Access Compliance Report Public Rights-of-Way (Curb Ramps)

Main Street: MC_KENZIE_DR Cross Street: ROCKAWAY_DR Location: NE

ADA ID: RPRK210917135644 Ramp Type: Type 1 - Perpendicular Diagonal Initial Pass/Fail: Pass Overall Compliance: No Severity Score: 4

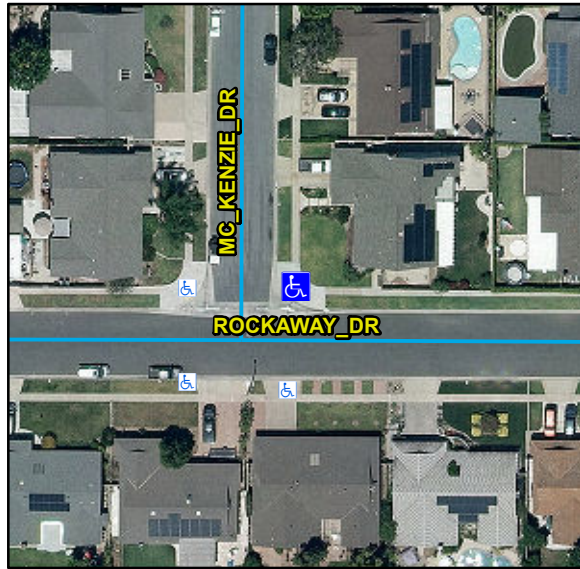
R304.2.2, R304.2.1, STD 1115

Remove & Replace Curb Ramp With Two New Directional Ramps or Equivalent.
